Access Compliance Report

Public Rights-of-Way

(Curb Ramps)

Intersection ID: 50464	Main Street: LENOX_POINTE_DR	Cross Street: SANDY_PORTER_RD	Location: SW
ADA ID: 4B6D722BF88F	Ramp Type: Perp	Initial Pass/Fail: Fail	Overall Compliance: No
Severity Score: 25			
Codes/Mitigation Info/Possible Solution		Field Measurements/Component Compliance

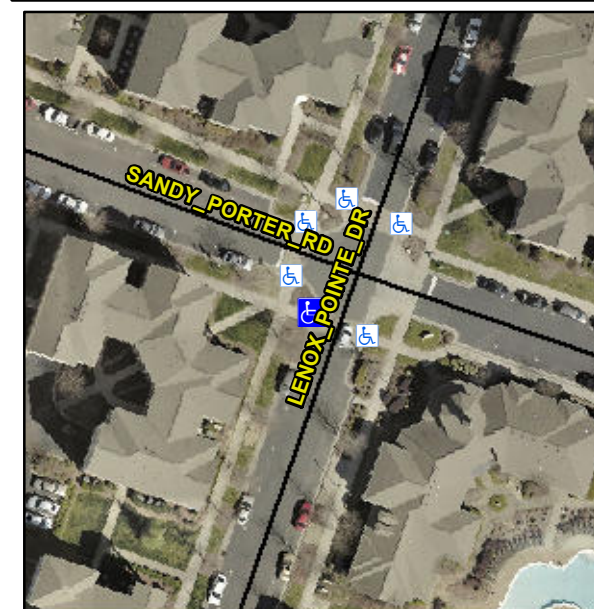
Not Found, R304.2.2

Compliance	Description	Data	Compliance	Description	Data
N/A	Ramp Length (in)	177.0	No	Ramp Slope (%)	14.9
Yes	Ramp Width (in)	48.0	Yes	Ramp XSlope (%)	0.5
N/A	Flare Type LT	N/A	N/A	Flare Type RT	N/A
N/A	Flare Slope LT (%)	N/A	N/A	Flare Slope RT (%)	N/A
N/A	Flare Traversable LT?	N/A	N/A	Flare Traversable RT?	N/A
N/A	Landing Length (in)	N/A	N/A	DWS Provided?	N/A
N/A	Landing Width (in)	N/A	N/A	DWS Contrast?	N/A
N/A	Landing Slope (%)	N/A	N/A	DWS Length (in)	N/A
N/A	Landing X Slope (%)	N/A	N/A	DWS Full Width?	N/A
N/A	Landing Curb? (Y/N)	N/A	N/A	DWS Offset (in)	N/A
N/A	Shared Landing?	N/A			
N/A	Gutter Ponding?	N/A	N/A	Gutter Slope (%)	N/A
N/A	Gutter Lip Ht (in)	N/A	N/A	Gutter X Slope (%)	N/A
N/A	Painted X Walk1?	Yes	N/A	Painted X Walk2?	N/A
	X Walk 1 Direction	To SE		X Walk 2 Direction	N/A
N/A	X Walk 1 Width (in)	144.0	N/A	X Walk 2 Width (in)	N/A
	X Walk 1 Slope (%)	1.5		X Walk 2 Slope (%)	N/A
	X Walk 1 X Slope (%)	0.9		X Walk 2 X Slope (%)	N/A

Remove & Replace Entire Ramp.
